Landscape Review Committee
Community Development Center, 231 NE 5th Street
August 21, 2019
12:00 PM

DATE: August 21, 2019
TO: Landscape Review Committee Members
FROM: Jamie Fleckenstein, Associate Planner
SUBJECT: Landscape Plan Review Application (L 10-19)

DECISION, CONDITIONS, FINDINGS OF FACT AND CONCLUSIONARY FINDINGS FOR THE APPROVAL OF A LANDSCAPE PLAN AT 4155 NE THREE MILE LANE

REQUEST: Approval of a Landscape Plan for an RV Storage Lot

Figure 5: Proposed Landscape Plan (Revised)

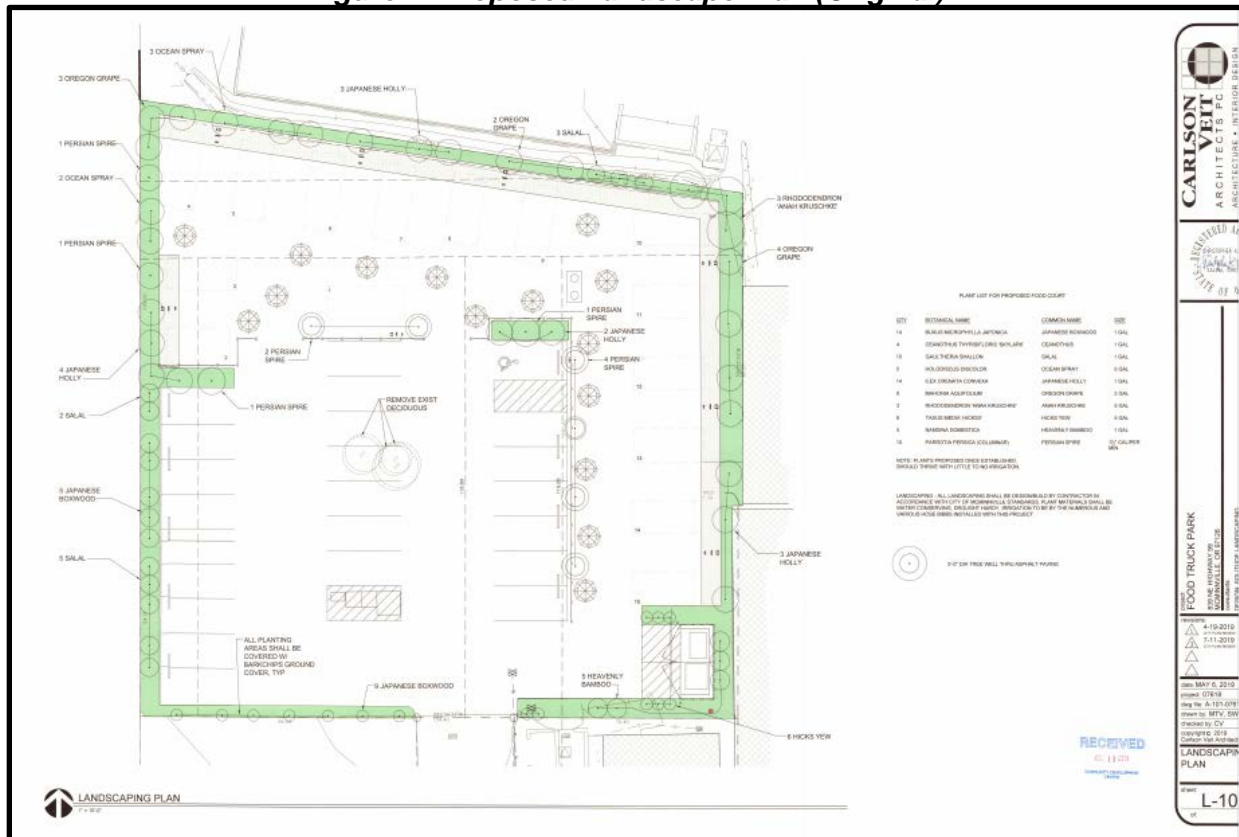
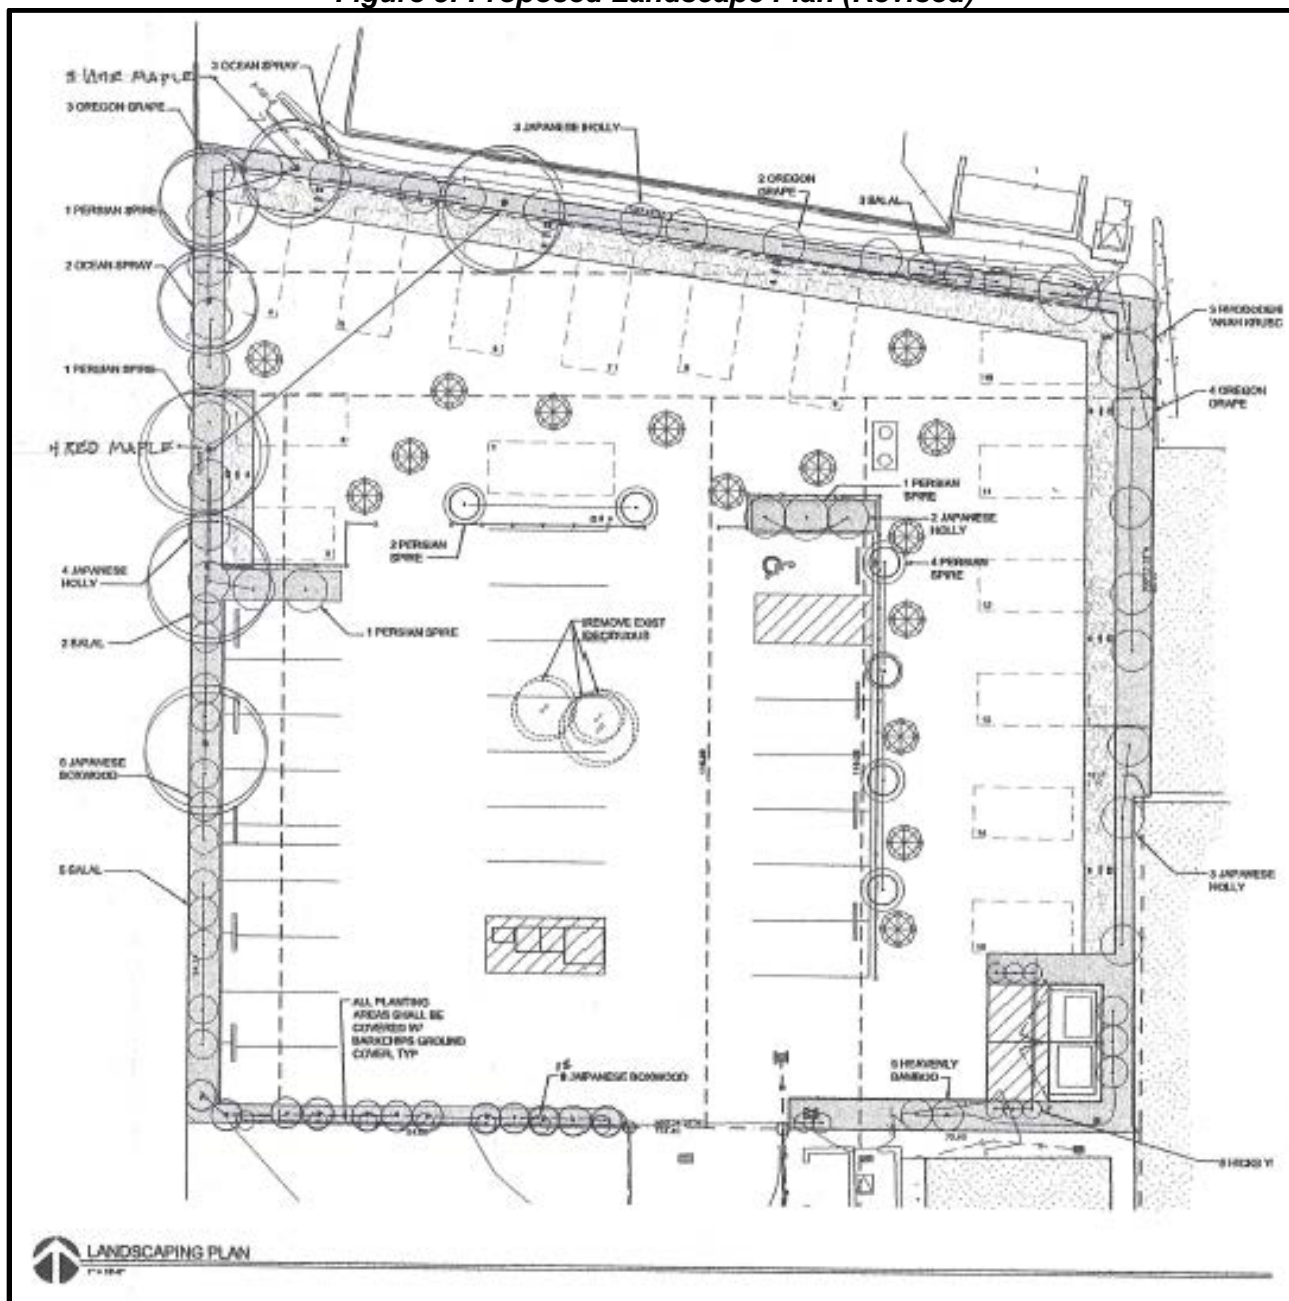
The original Landscape Plan (Figure 4) was presented to the Landscape Review Committee at their July 17, 2019 meeting. The committee did not find that the proposal sufficiently satisfied the development code and continued the application to allow the applicant the opportunity to revise the landscape plan to respond to the committee's comments. The applicant has submitted a revised landscape plan for the committee's consideration (**See Figure 5 – Proposed Landscape (Plan Revised)**).

Landscaping – South Property Line

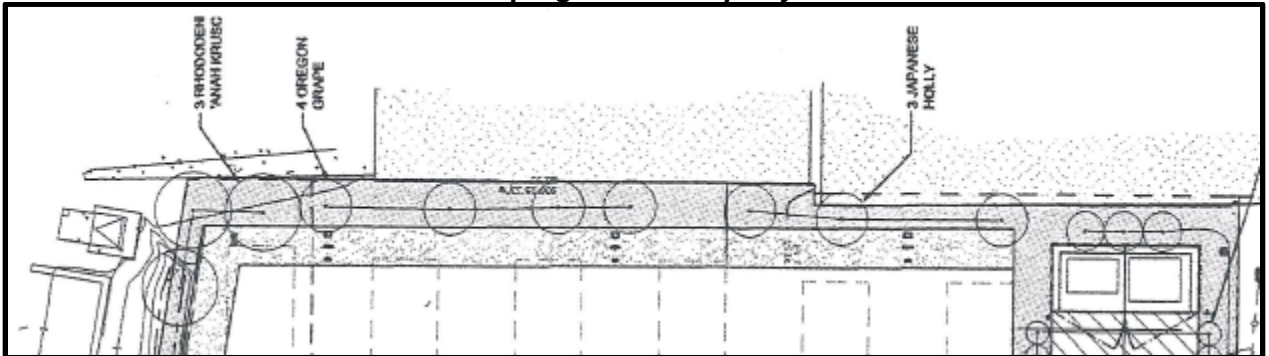
Landscaping along the south property line west of the driveway is located in a three (3) foot wide planting bed in front of an existing fence on the adjacent property. A row of 12 Japanese Boxwoods are proposed spaced at five (5) feet on center. East of the driveway and in front of the adjacent trash enclosure, additional Japanese Boxwoods are proposed. These are in the vicinity of a future water meter and backflow, and spacing standards will be required to be met. In the southeast corner of the site, adjacent to two blank walls of adjacent buildings, is the proposed trash enclosure for the subject site. Landscaping is provided around the enclosure – Hick's Yews on the sides, and Heavenly Bamboo between the enclosure and the adjacent building. Hick's Yews grow up to 12 feet in height and 4 feet wide, and Heavenly Bamboo grows to approximately six (6) feet high and wide. Both are evergreen shrubs and would provide screening and buffering of the trash enclosure.

Landscaping – East Property Line

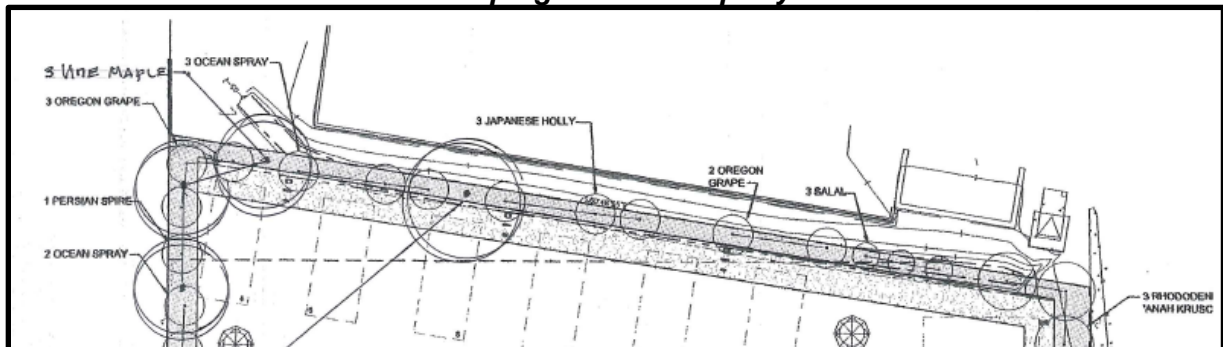
Along the east property line, plantings of Oregon Grape and Japanese Holly are proposed in front of the adjacent commercial buildings. Both are evergreen shrubs that can reach up to six (6) feet tall and wide. Oregon Grape is a Pacific Northwest native. In the northeast corner, a group of Anah Kruschke Rhododendrons is proposed. Anah Kruschke Rhododendron also grows to approximately six (6) feet tall and wide.

Landscaping – North Property Line***Attachments:***

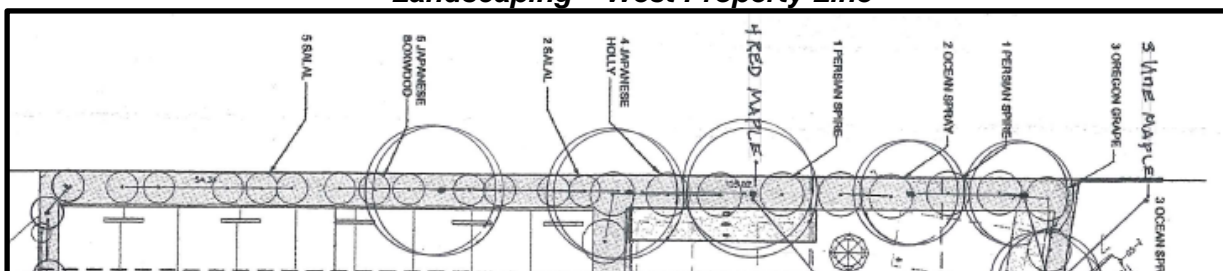
Plants along the north property line, located between the food truck spaces and the adjacent parking lot to the north, are a combination of Oregon Grape, Japanese Holly, Salal, and Ocean Spray. A Red Maple tree is also located in this area. Plants are spaced to provide groupings of shrubs, not a continuous border. This is generally compatible with the proposed use on the site and the uses on adjacent sites. The space between plant groupings would allow customers to walk from adjacent commercial uses or parking to the food truck park. The porous nature of a large food truck pod such as that proposed is supported by the perimeter planting.

In the northwest corner of the property, Vine Maples, Oregon Grape, and Ocean Spray provide additional screening and buffering of the property from the nearby residential neighborhoods.

Landscaping – West Property Line

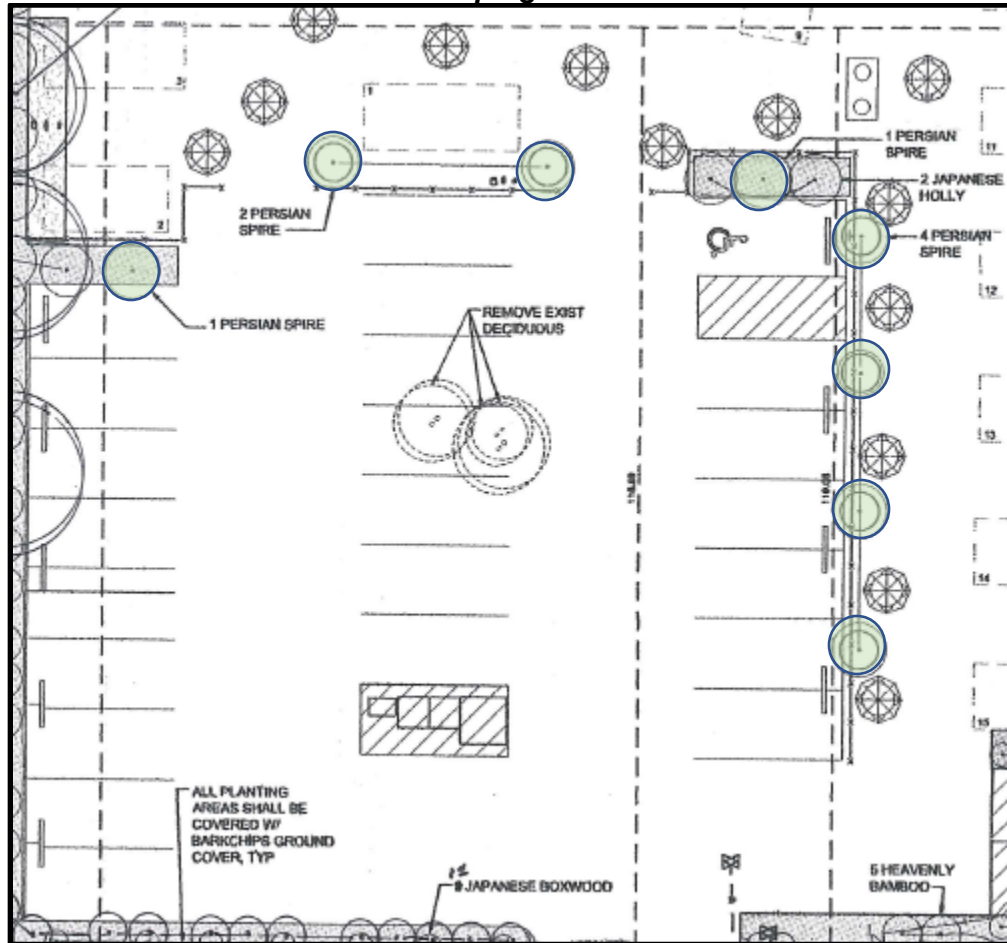
Proposed planting along the western property line features trees (Vine Maples, Persian Spire Parrotias, and Red Maples) and shrubs (Japanese Boxwood, Salal, Japanese Holly, and Ocean Spray). Salal is a native evergreen shrubs that remains low (up to two (2) feet) in full sun. Red Maples are shade trees that grow to 40 feet tall and wide, depending on the specific variety. The Red Maples are shown at approximately 20 to 25 feet on center. Also along the west property line are two (2) Persian Spire trees. These deciduous, columnar trees grow up to 25 feet tall by 10 feet wide, and with strong fall color. However, they are located immediately adjacent to the northernmost Red Maple and the southernmost Vine Maple. The growth characteristics of these trees are incompatible in immediate adjacency. A condition of approval has been included to remove the Persian Spire trees from the western property line in favor of the broader canopy maple trees to allow the canopy trees opportunity to thrive. Also in the condition is the provision of the red maple trees at regular spacing to the southern property line to provide shade to the parking lot, as described in more detail below.

Figure 4: Proposed Landscape Plan**Summary of Criteria & Issues**

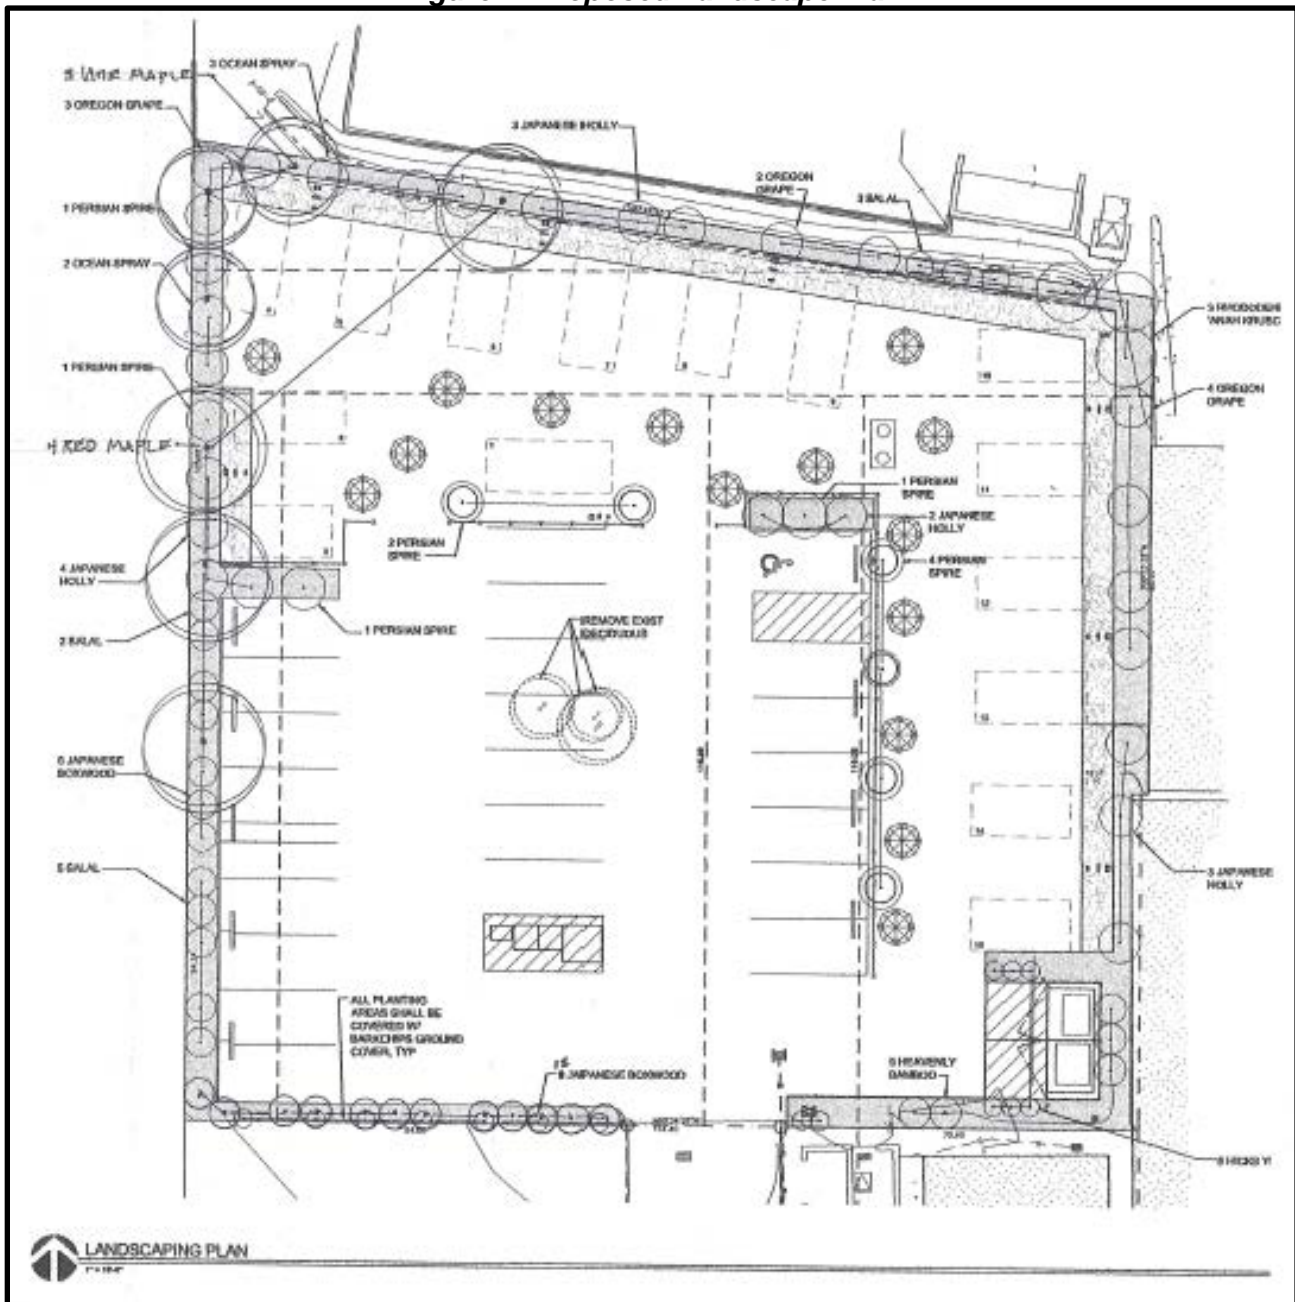
The subject site is zoned C-3 (General Commercial). The Landscaping chapter of the McMinnville Zoning Ordinance requires that at least seven (7) percent of the gross area of an commercial site being developed be landscaped (Section 17.57.070(A)(2) (Area Determination – Planning Factors)). The application indicates that landscaping in excess of the required seven percent is being provided.

3. That a non-columnar *Acer rubrum* (Red Maple) variety such as 'Franksred' (Red Sunset) or 'Frank Jr.' (Redpointe) be planted at 25 feet on center along the western property line, from the southern property line to approximately food truck space #3 (as indicated on the landscape plan). *Parrotia persica* 'JLColumnare' (Persian Spire Parrotia) shall not be planted along the western property line.
4. That all landscaping approved by the Landscape Review Committee and required as conditions of approval shall be maintained, including necessary watering, weeding, pruning, mowing, and replacement.
